Indoor Station Firmware V2.2.2_build221129

Release Note (2022-12-02)

Device Model	DS-KH8350-WTE1, DS-KH8350-TE1, DS-KH6320-WTE1, DS-KH6320Y-WTE2, DS-KH6320-WTE2(B), DS-KH6320-TE1, DS-KH8520-WTE1
Firmware Version	V2.2.2_build221129
iVMS-4200	V3.8.3.1 or later

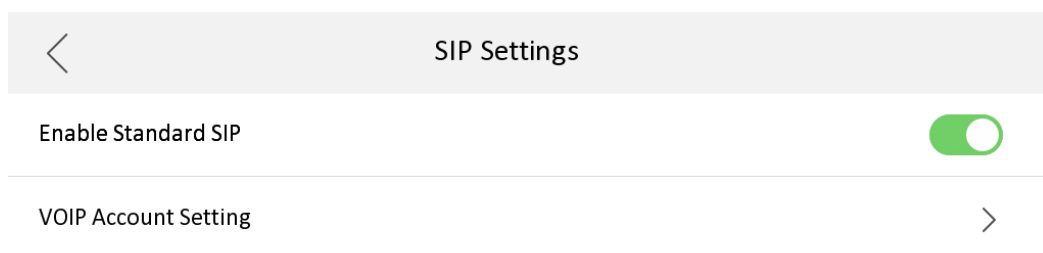
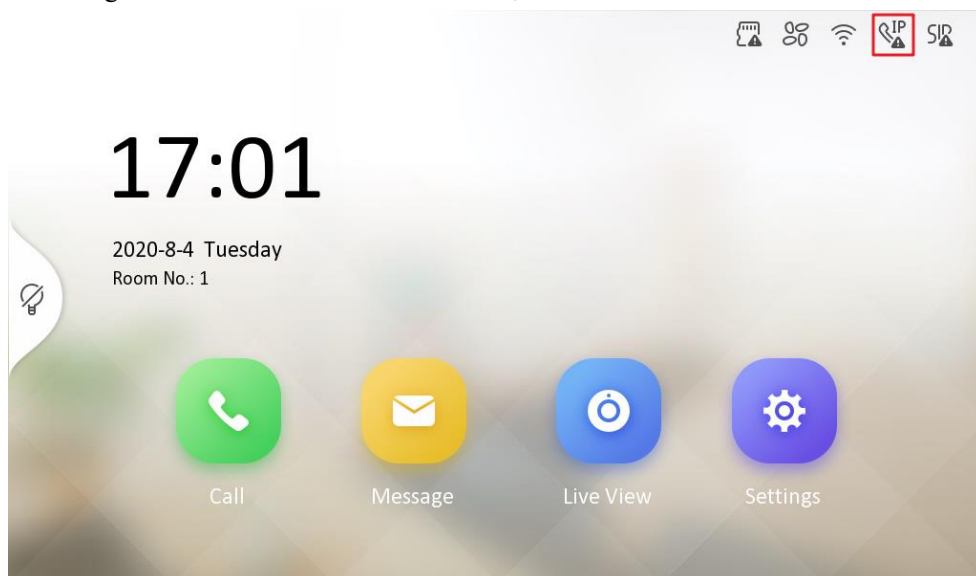
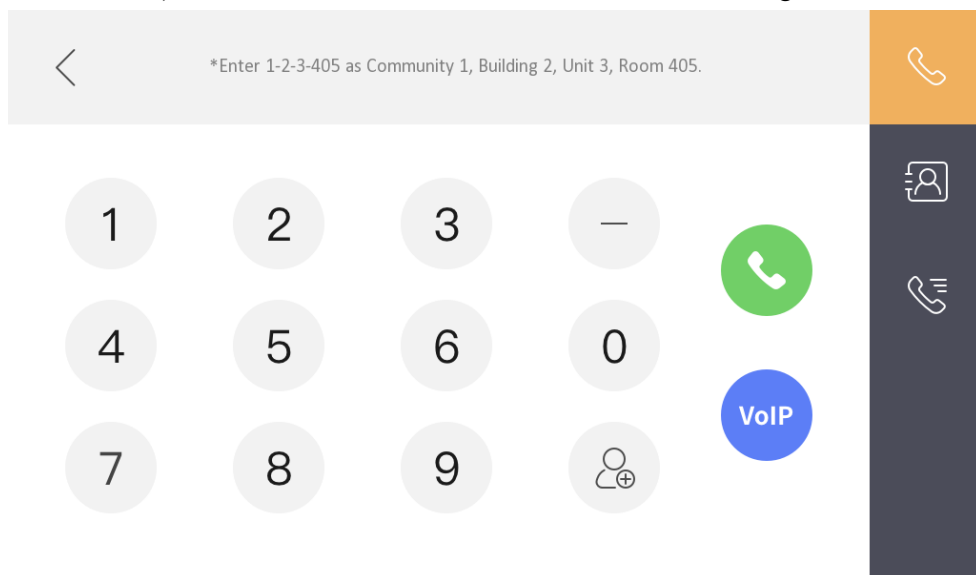
- b) The standard SIP of the indoor station is disabled by default, if you want to connect to a third-party standard SIP device, you need to turn on this function.

- c) A standard SIP registration status icon is added to the main interface, which can be displayed/hidden

according to whether standard SIP is enabled;

d) Added a VoIP call button in the call interface to distinguish standard SIP calls
